Urban Design Assessment Report

MFC Commercial Development

110 Jervois Quay, Wellington

SR_510418

Figure 3: Elevation of the southern facade, extending along the Wakefield Street frontage. note the expression of the three compositional elements; the Lantern, West Wedge and East Wedge.

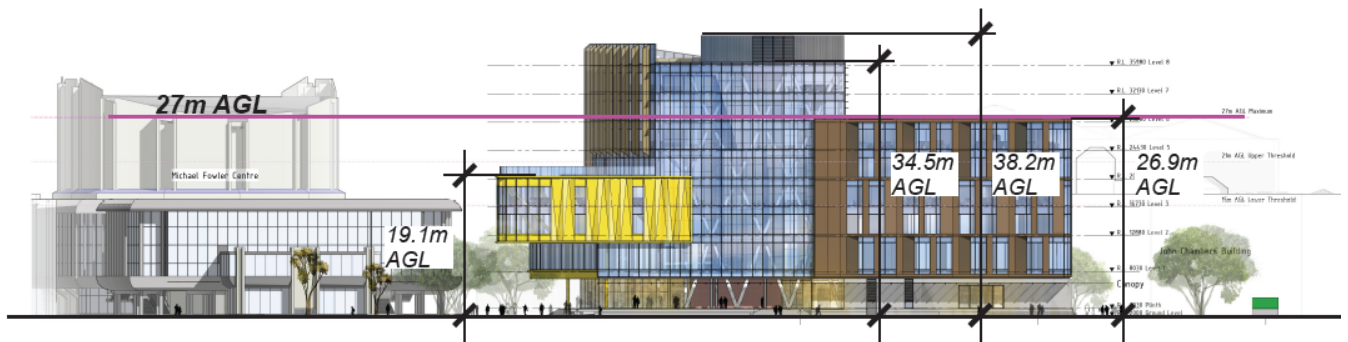
While the Lantern façade cladding is largely a patterned curtainwall, the two wedge forms develop façade patterns using solid and transparent elements that recall the pattern set up by the curtainwall as well as fenestration seen on buildings in the surrounding area.

The various façade treatments, including colour, help reinforce the three volume composition and enhance visual interest. The proportions set up in the grid of the glazing bars of the curtainwall create a form of backcloth helping to link the three parts of the form to one another. Over this fabric, a pattern of solid/void is set up in the facades of the two wedges to generate a rhythmic overlay on the surfaces and help to distinguish these parts. As noted in the UDP report, the yellow colour proposed for the West Wedge is appropriate in relation to the Cuba Precinct of the city.

The three components of the building are each expressed individually and in ways that help ensure strong visual interest and appropriate connections are established with surrounding buildings and spaces. The plantroom adopts a contrasting, screen form of wall cladding that creates a distinct cap over part of the Lantern form. In my view this can be an effective design treatment provided the materials and detailing of the plantroom is appropriate. I note here also that the alignment between the two claddings is very close on three highly visible facades. As such, achieving appropriate visual details is critical to the

I agree with the UDA that the silhouette of the proposed development is interesting from a range of different viewing points. The manner in which the plant room is integrated with the facades below is critical to the success of the roof design, however. As noted above, this will need to be carefully considered at following stages of design development, should resource consent be granted. Moreover, when viewed from above, the effect of plant located external to the plantroom is unclear. The drawings provide little understanding of the mechanical plant, noting that figs. 59 and 60 of the ADS present conflicting representations of the size of this plant. Should resource consent be granted, it would be important to allow a condition requiring this aspect of the design to be checked early on, with a view to minimising visibility from surrounding public spaces and from elevated positions.

There is a distinct lack of parapet around the edges of the various roof surfaces, which can lead to unintended visibility of minor roof mounted elements. This should also be carefully considered as the design continues to be developed and certainly should be incorporated into the roof design consent condition referred to above.
